RE: License SUB-1010; Docket No. 40-8027
License Amendment Application
License Condition 15, Tamper Detection Device for UF₆
Cylinder Valves; Organizational Change; and Minor
Process Change in UF₆ Reduction Plant

Sequoyah Fuels Corporation (SFC) submits this application for amendment of Condition 15 of the subject license. SFC would like to remove the association of Condition 15 with a licensee letter to your office dated September 16, 1988. SFC would prefer Condition 15 to read "The licensee shall implement a method to "tamper safe" UF₆ cylinder valves."

TAMPER INDICATING DEVICE

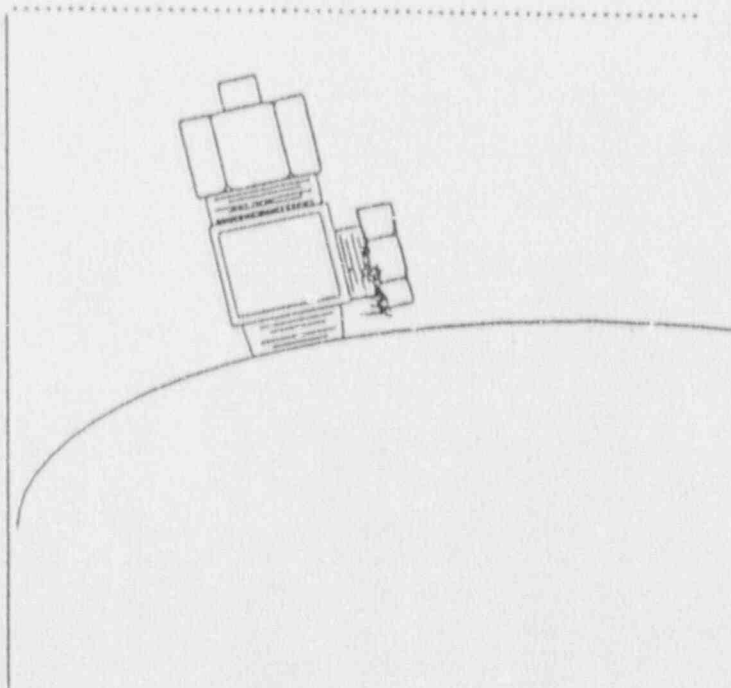
As a cost saving measure, SFC is considering adopting the "tamper safe" method employed by the Department of Energy (DOE). A description of the "tamper safe" device currently in use by DOE is exhibited on an attachment to this letter. By removing the restriction implied by the referenced letter of September 16, 1988, SFC will be able to adopt and maintain a "tamper safe" method that is consistent with current industry practice and can remain so as practices change or conditions warrant. SFC intends to exhaust its current supply of "tamper safe" materials, prior to changing to the DOE method.

1. Cup fits over entire valve.
2. Flag is installed through holes and underneath valve port.
3. Flag locks cup in place.
4. Seal is attached to flag. Flag cannot be removed without breaking seal.

Figure 11-1

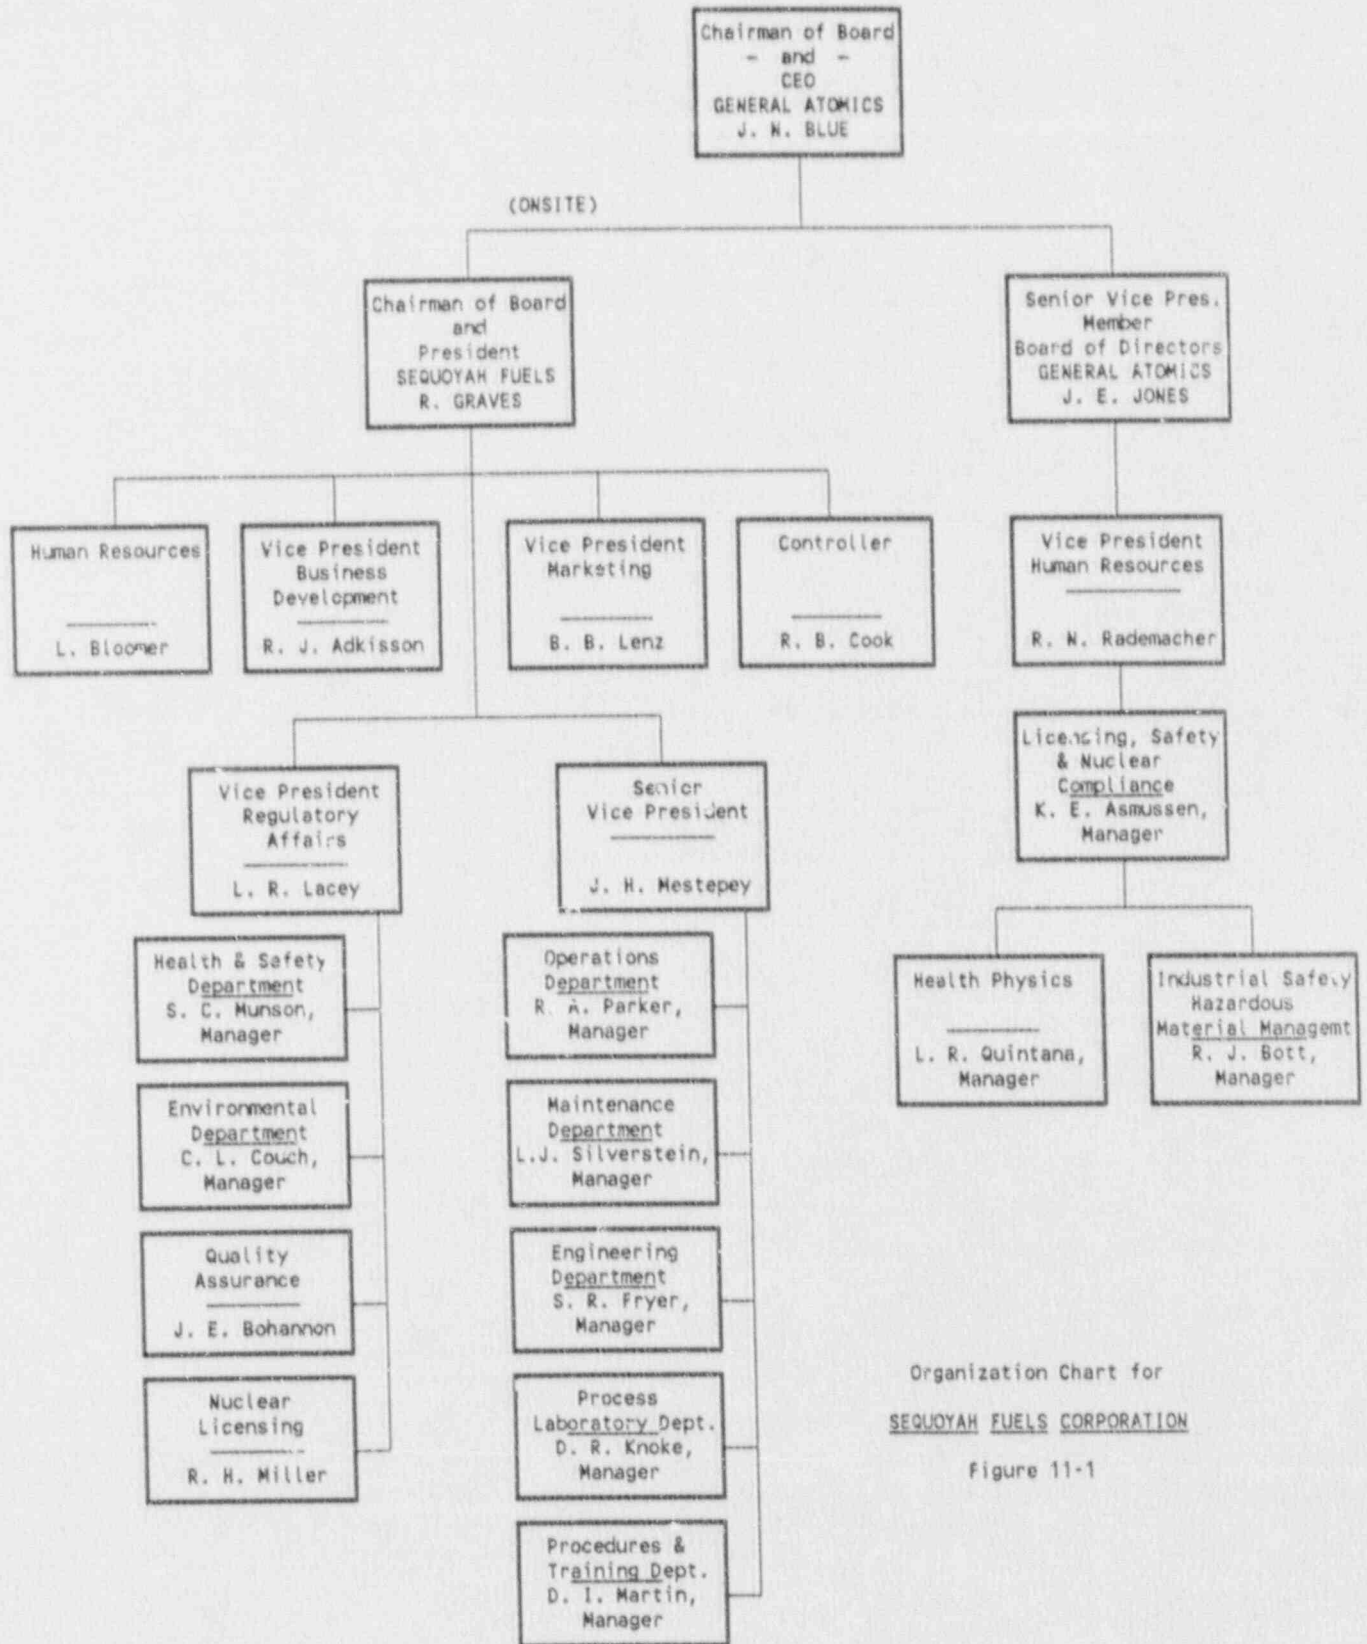
Additionally, Chapter 11 has been revised to reflect that Scott Munson is the Manager, Health and Safety, and Laurence Silverstein is the Manager, Maintenance. Chapter 16 has been revised to include description of a magnetic separator to be installed in the DUF₄ product handling and packaging line, prior to restart of the UF₆ Reduction Plant later this year.
